# NESC Review of the 8-Foot High Temperature Tunnel (HTT) Oxygen Storage Pressure Vessel Inspection Requirements

<b>NASA Engineering and Safety Center Technical Consultation Report</b>	Document #: <b>RP-05-113</b>	Version: <b>1.0</b>
Title: <b>NESC Review of the 8-Foot High Temperature Tunnel (HTT) Oxygen Storage Pressure Vessel Inspection Requirements</b>			Page #: 1 of 29

**March 16, 2006**

**Appendix B. LOX Run Tank Sketch**

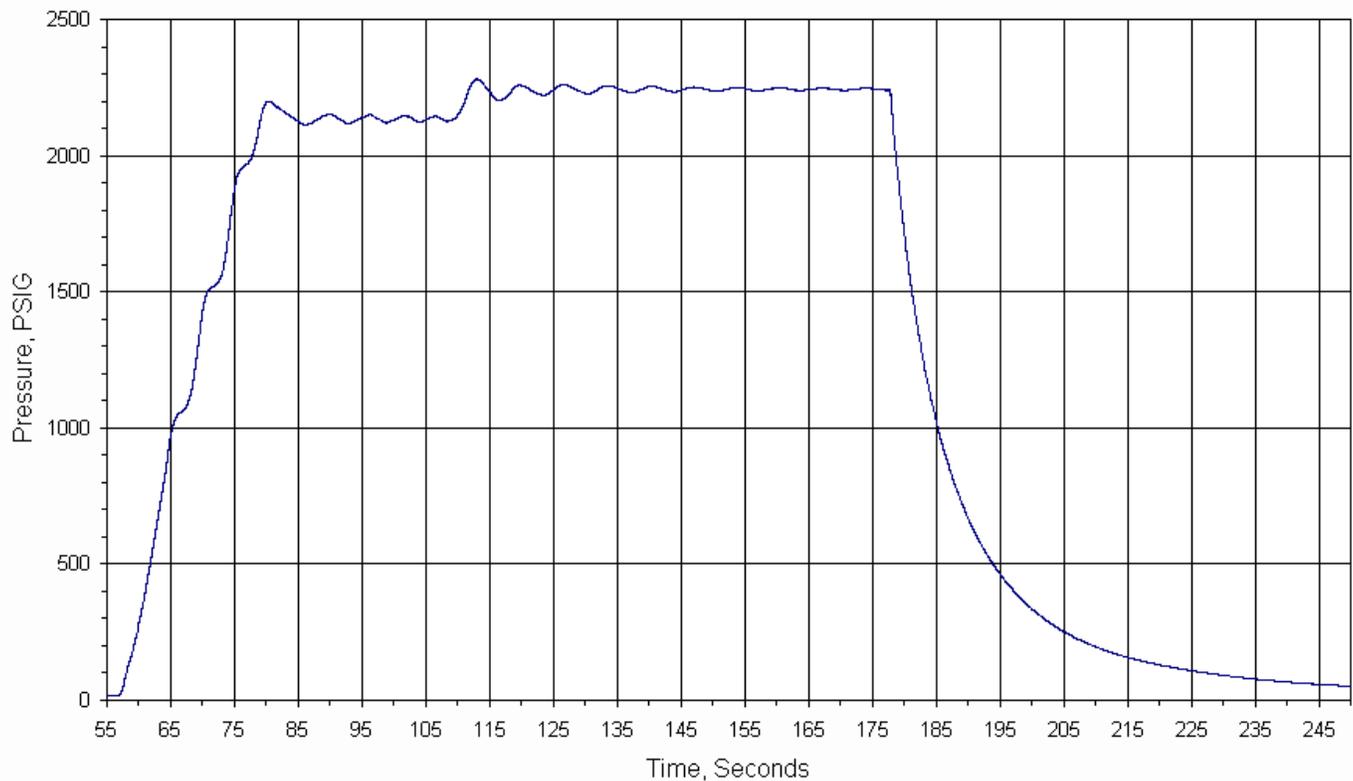
#### **LOX Run Tank (Refer to the sketch in Appendix B)**

- The tank was determined to be LBB by analysis.
- Monitoring of the vacuum level between the inner pressure shell and the external shell would identify the presence of through-cracks in the pressure shell and allow the facility to stop operations before catastrophic failure would occur.

- F-1.** The damage tolerance analyses are insufficient to demonstrate LBB for the LOX Run Tank for the following reasons:
- Critical crack size is predicted to be less than the tank wall thickness.
  - Fracture mechanics analyses did not account for weld material properties or residual stresses.
  - The structural finite element models do not capture changes in thickness, geometry, loading, and material properties.

The tank, as constructed, contains welded-in forgings for the upper access port and nozzles at both the top and bottom of the tank. The properties of the weld material and the forgings differ from the properties of the material used for the tank walls, even though both the tank wall and forgings are 347 Stainless Steel. The crack growth analysis assumed uniform material properties for all sections of the tank and did not include analyses of the welds. In addition, material properties for 304 Stainless Steel were used in the analyses as being representative of 347 Stainless Steel because material properties for 347 Stainless Steel were not readily available.

Although a critical crack size less than the tank wall thickness was predicted, it was assumed that the crack would also grow perpendicular to the thickness until reaching an adjacent nozzle opening, which would act as a crack stop. The crack would then be

stable (not growing) and be more than twice the wall thickness in length, thus satisfying LBB criteria.

This assumption did not account for the weldments or the changes in material properties along the assumed path of the crack and, therefore, is invalid. Also, the NASA standard for LBB is crack length 10 times the wall thickness, whereas the analysis was based on crack length 2 times the wall thickness. Refer to Observation O-3.

**F-2.** The fatigue analysis method used is inconsistent with the original fabrication inspection performed on the LOX Run Tank for the following reasons:

- The fatigue analysis was performed according to the American Society of Mechanical Engineers (ASME) Section VIII, Division 2. Application of this analysis is based on construction of the tank to ASME Section VIII, Division 2, which requires stringent manufacturing inspections. These inspections set the initial crack size to be used in subsequent fatigue analyses based on the actual minimum detectable flaw size at the time the inspections were conducted.
- The LOX Run Tank was actually constructed to ASME Section VIII, Division 1, with much less stringent quality assurance, inspection, and process controls.
- The ASME Section VIII, Division 2, fatigue analysis was performed based on an *assumed* crack size rather than the minimum detectable size from the manufacturing inspection process.

**F-3.** The LOX Run Tank fatigue life calculations do not currently account for pre-LaRC use. The tank was manufactured in 1959, but was first put into service at the HTT in 1989. Since 1989, the LOX Run Tank has been subject to about 600 pressure cycles. The tank operational history prior to service at the HTT is not accounted for, nor has it been demonstrated that the tank was restored to "zero-time" status in 1989.

**F-4.** All previous tank inspections have revealed cracks and/or crack-like indications that were repaired or removed. The inspection history, shown below, suggests that cracks continually initiate or that the inspections may not have found all flaws.

- 1965: Cracks in 4-inch boss weld repaired
- 1986: Four linear indications found and ground out
- 1991: Six linear indications found and ground out

**O-3.** The “ten times the thickness” NASA standard is applicable to thin-walled pressure vessels and pipes. For thick-walled pressure vessels (such as LOX Run Tank of 4.73 inches in thickness), the NASA standards are not clearly defined and the Nuclear Industry Code for LBB conditions should be used. The Nuclear Industry Code LBB conditions require the development of a through-the-thickness crack with sufficient crack opening for the fluid to leak and be detected.

O-4. Atmospheric pressure load modeling in the revised analysis needs to be updated; the overall effect is expected to be very minor (order of 14/2250 psi).

- The atmospheric pressure acts on the external vacuum jacket shell and transfers to the LOX Run Tank pressure shell as point loads through standoffs, not as a uniform load on the pressure shell.

O-6. Vacuum monitoring of the LOX Run Tank as a safety precaution may lead to a false sense of security.

**R-1.** Remove the LOX Run Tank from run-time pressure service until the LBB rationale is verified and the risk of continued operation is accepted, or until an inspection is performed and any detected flaws are properly dispositioned (F-1, F-2, F-3, F-4 and F-6).

R-1 (Revised). Based on conservative analysis assumptions and large analytical margins in the revised fatigue and fracture analyses, the NESC Technical Consultation Team's position on the LOX Run Tank is:

- Completion of the Air Force Research Lab (AFRL) Ground Demonstration Engine test program is acceptable, based on an assumed test program of less than 100 additional pressure cycles of the LOX Run Tank.
- The LOX Run Tank should be inspected and recertified immediately following the completion of the AFRL tests before any additional test programs are conducted.

### **Appendix C. LOX Run Tank Analyses**

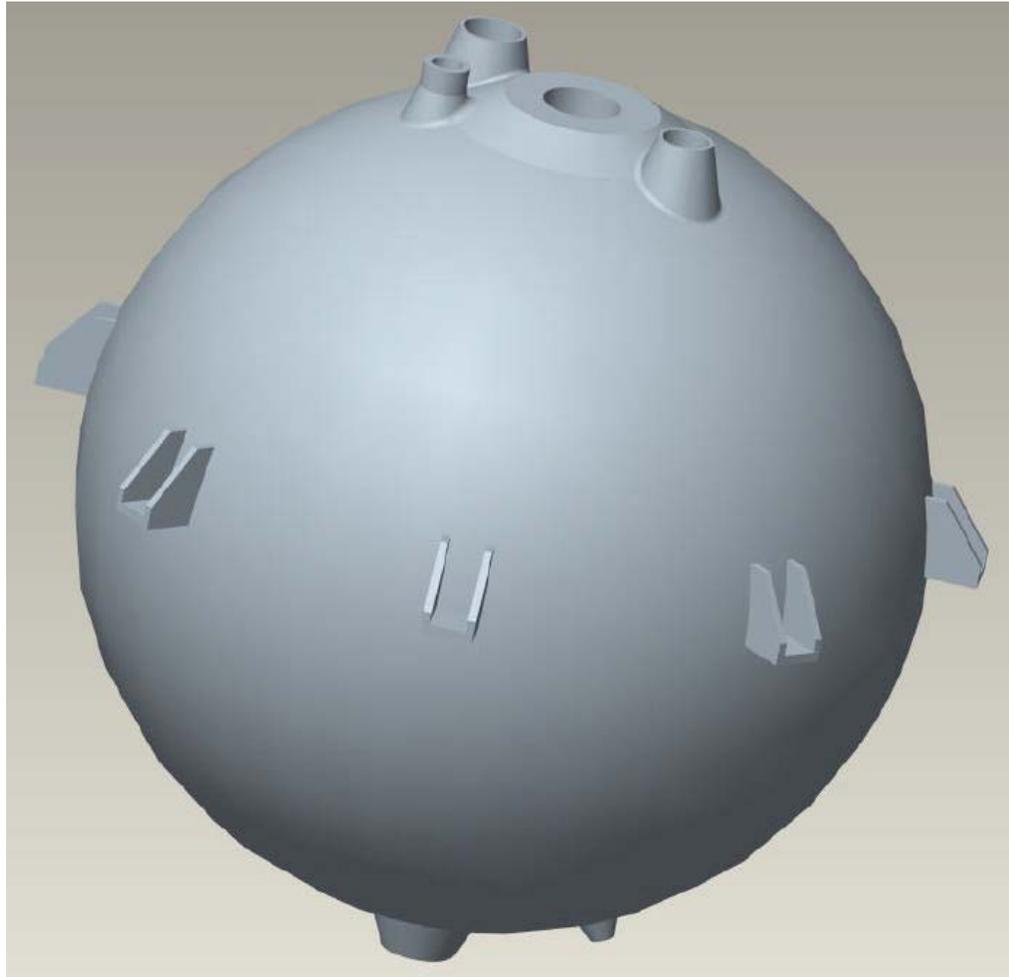
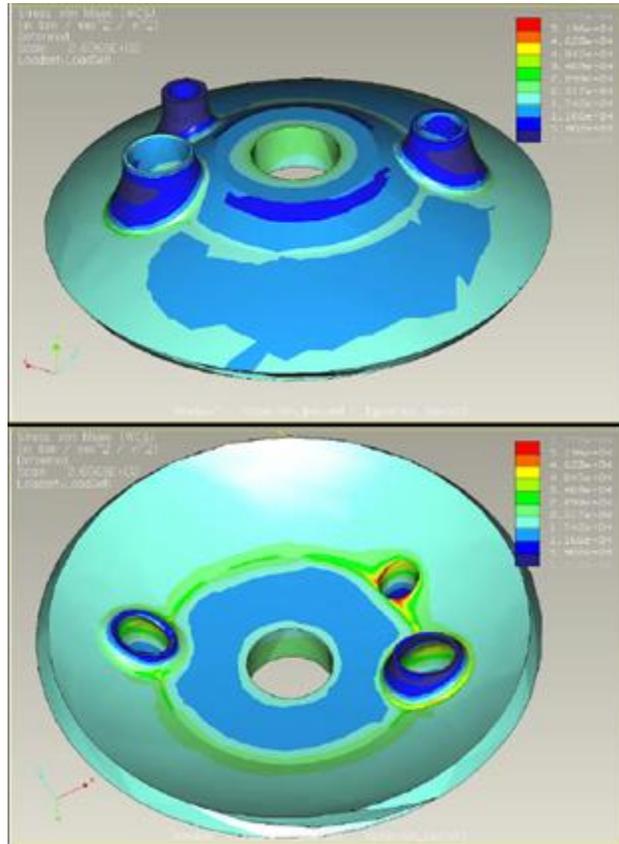
The NESC Review Team reviewed the stress, fatigue, and fracture analyses of the LOX Run Tank. The individuals that performed these analyses were interviewed by the NESC Review Team to gain full understanding and to resolve any questions. The results of the data analyses are documented in Section 8.1, Findings.

Refer to Appendix C for key analyses figures reviewed by the team.
